**Environmental Licensing Programme  
 Addendum to Inspectors Report**

<b>To:</b>	Directors
<b>FROM:</b>	Michael Owens - Environmental Licensing Programme
<b>DATE:</b>	31/01/11
<b>RE:</b>	Application for a Waste Licence from Roadstone Wood Ltd, Fortunestown, Tallaght, Dublin, 24. Licence Register W0269-01

**Figure 1 – Site Boundary and Locations of Water Features**

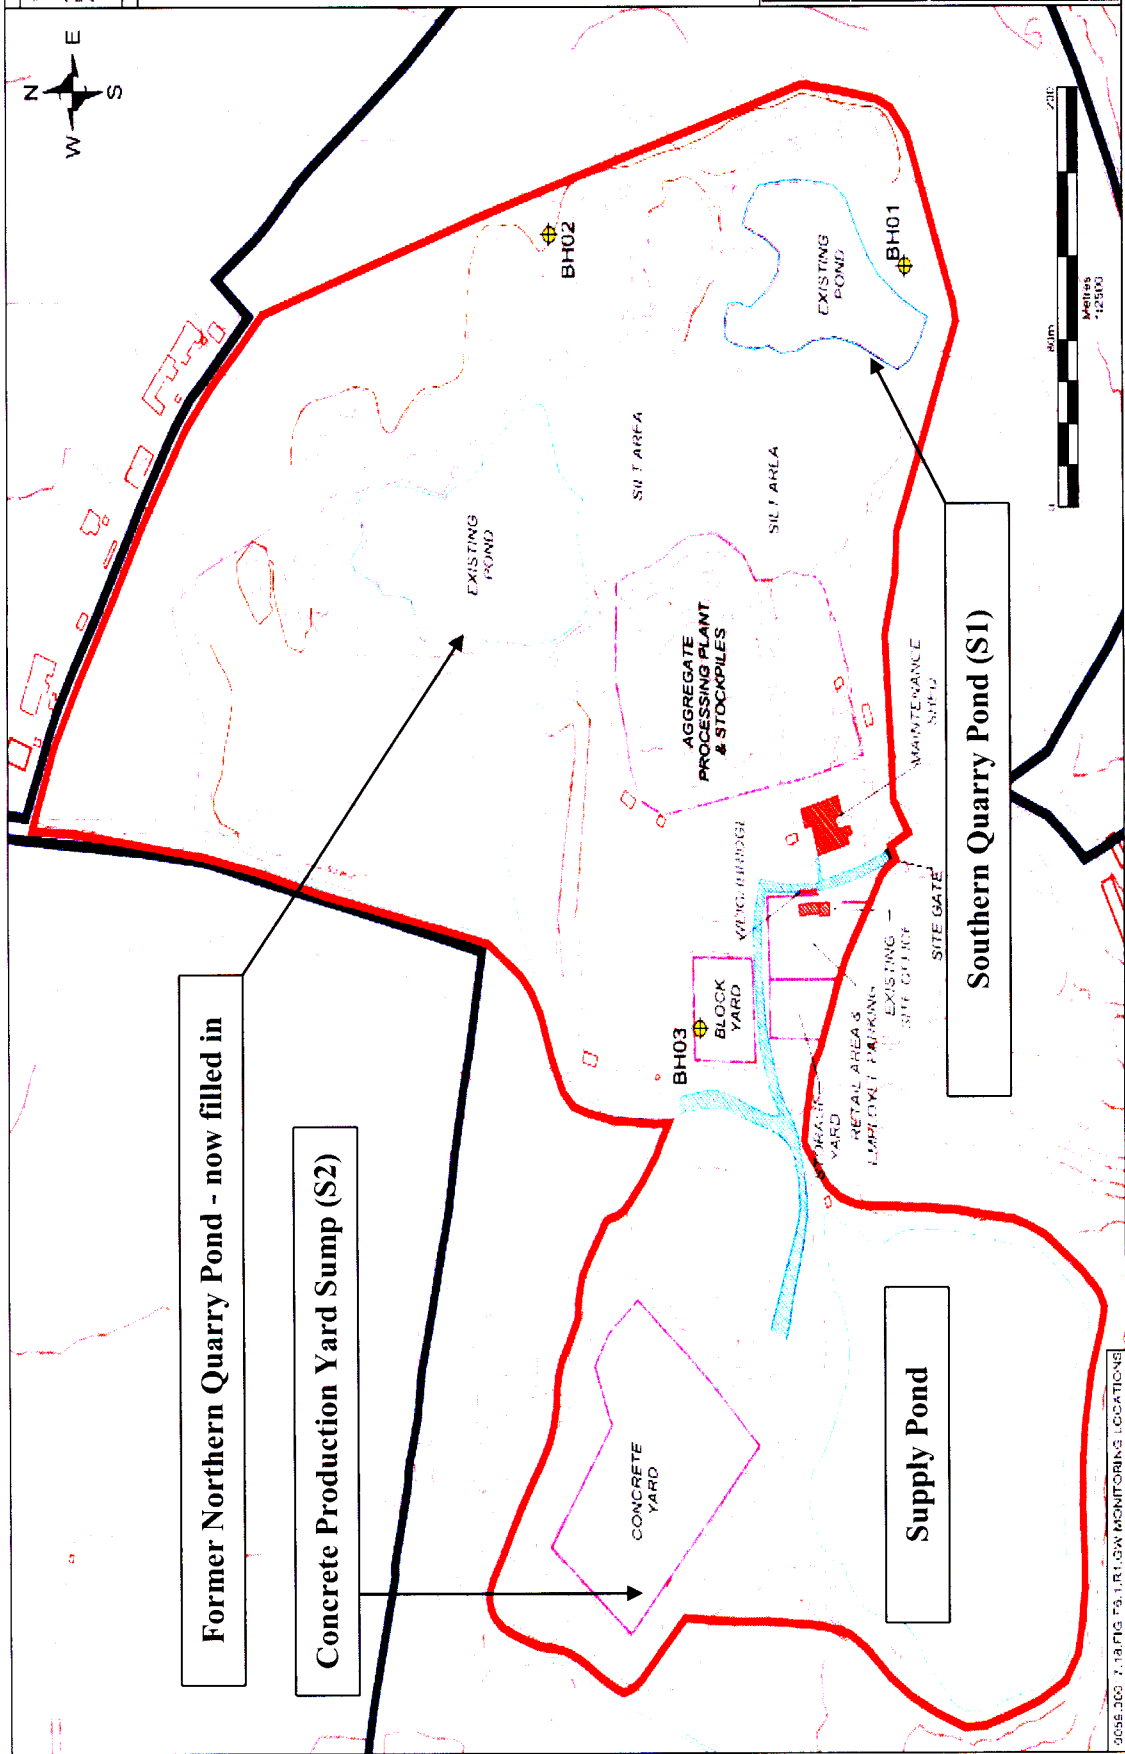
According to the additional information received from the applicant, it is necessary to provide an update on the situation regarding the nature of the various water features in and around the facility (refer to Figure 1 attached to this report).

- (i) Northern quarry pond - Originally designated as SW1 in the RD. This pond no longer exists as all water has been pumped to the southern quarry pond (see (ii) below). The area where the northern quarry pond was located has been backfilled. This backfilling was carried out under a waste facility permit. All reference to the northern quarry pond is now removed from the RD.

- (ii) Southern quarry pond - Originally designated as SW2 in the RD. Water in the quarry now remains only in the southern quarry pond at the southern end of the existing quarry void. The southern quarry pond is now designated as S1 in the RD. See Section 3(i) below for more detail on the southern quarry pond.

- (iii) Storm water in the collection sump in the concrete production yard - Originally designated as SW3 in the RD. This sump collects storm water that runs off the hard surface of the concrete production yard. This feature remains unchanged but is now designated as S2 in the RD. See Section 3(ii) below for more detail on the concrete production yard sump.

- (iv) Supply pond – This pond lies due south of the concrete production yard. This pond was left outside the original licence application boundary; however, following direction from the Agency in the Article 16 Notice issued on the 17/12/10, the licence boundary has been amended so that the supply pond now lies *within* the licence boundary. See Section 3(iii) below for more detail on the supply pond.
